**Contract Change Order # 1**

Project Name: LLWWTP Maintenance Building Addition Project Number: 165415

Project Location: Lynn Lane WWTP Date of Application: Monday, January 23, 2017

**Drawing:** M 1.1  
**Cost Impact:** None

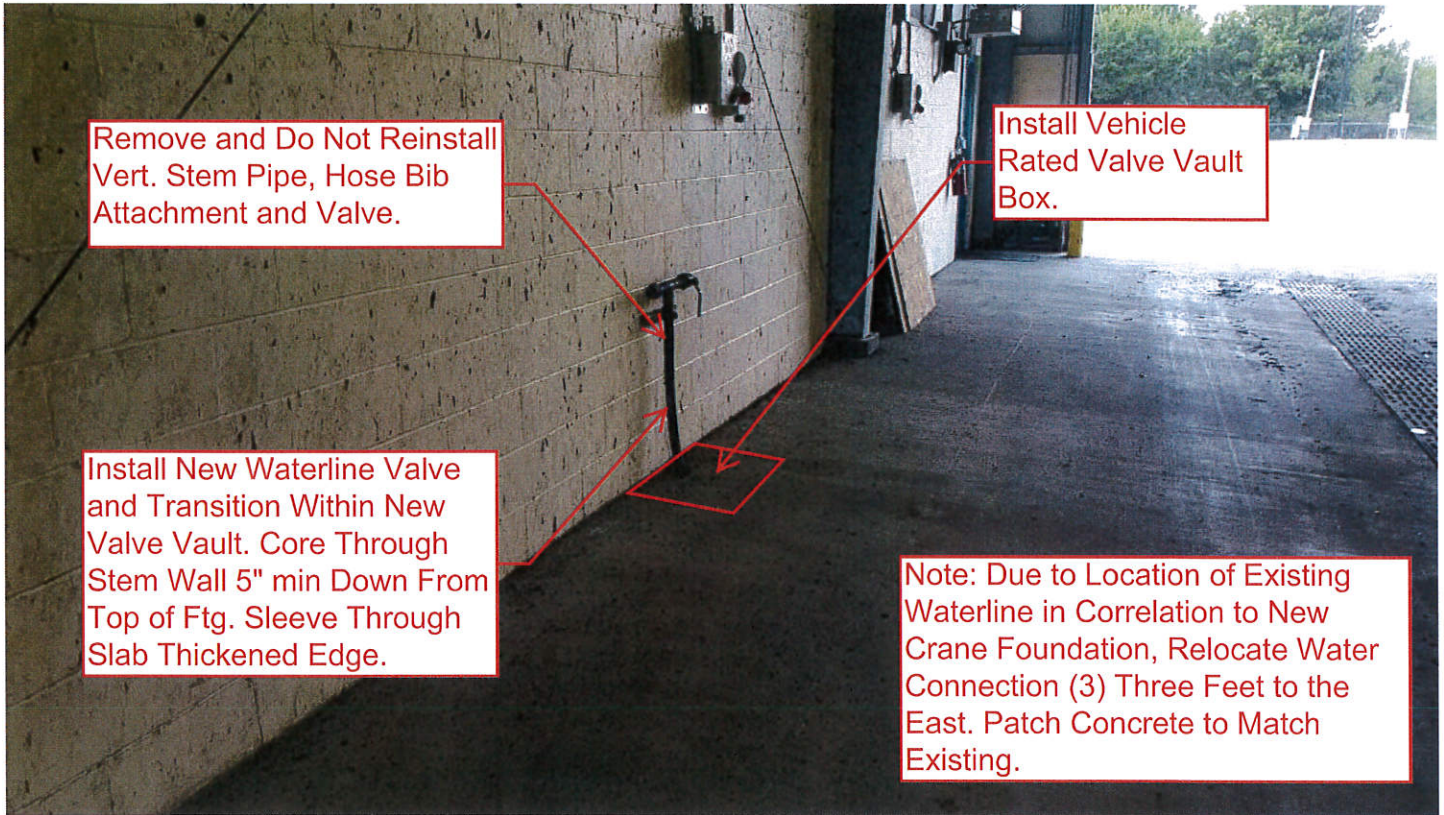
**Request:** **Date Required:** 9/15/2016  
We would request that the 1 1/4 inch water line be routed overhead and insulated after the installation of the shut off valve at the tap. This will not interfere with the monolythic slab and footings and reinforcing steel. All other aspects will remain the same. It will be supported from the new building structure and be insulated.

The above purposed resolution is rejected, however please see attached for an alternate method of installation. After reviewing the existing building foundations and bearing material, COBA does not want to disturb the bearing material supporting the existing building. The existing waterline inside the building is to be excavated such to accommodate a drivable valve box to allow for a transition through the top of the stem wall footing. The hose connection and vertical piping shall be removed and not reinstalled. See attached plans for further clarifications.

# 12" x 12" BOX ASSEMBLY

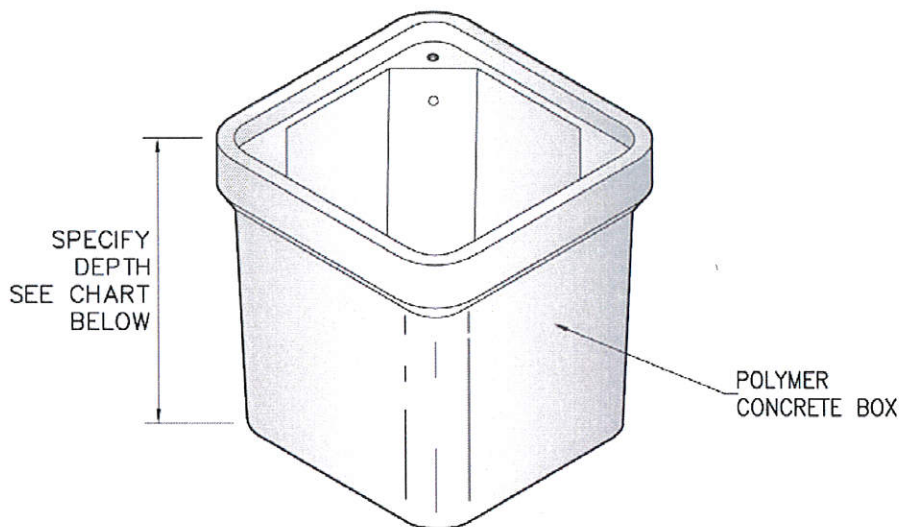
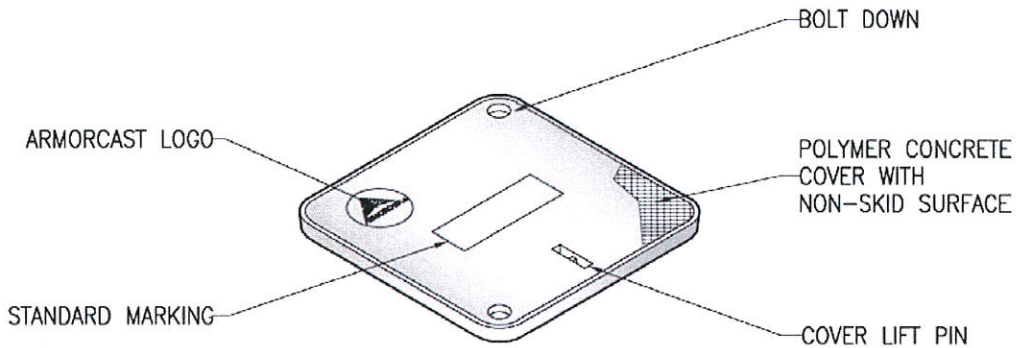
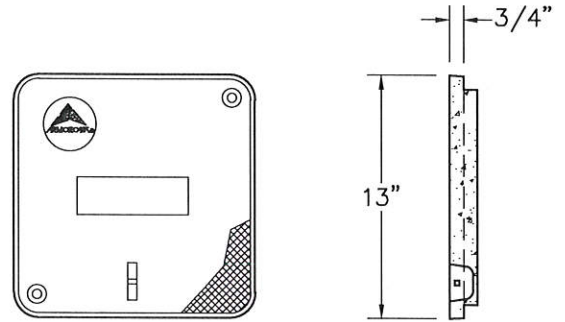
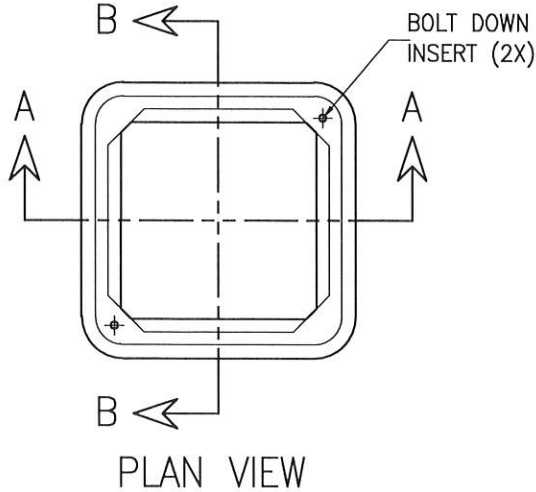
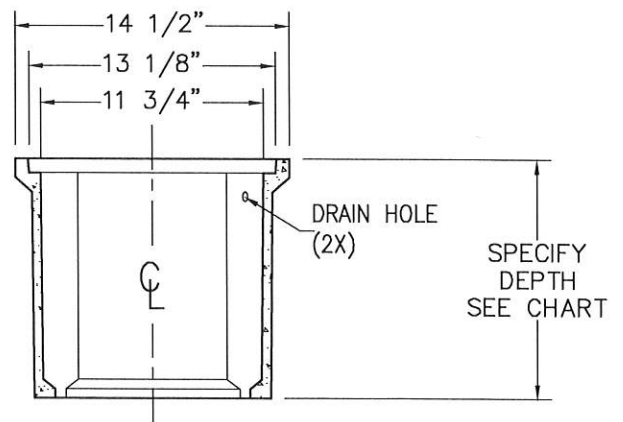
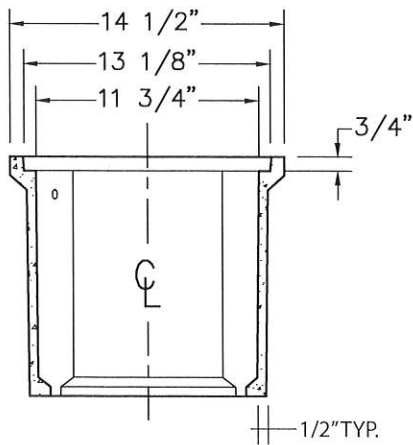
The City's response to RFI No.2 now requests the demolition of the existing above ground piping and the installation of a 12 x 12 box assembly, core drilling the concrete, and installing the shut off valve in the box. The additional cost for this revision is as follows:
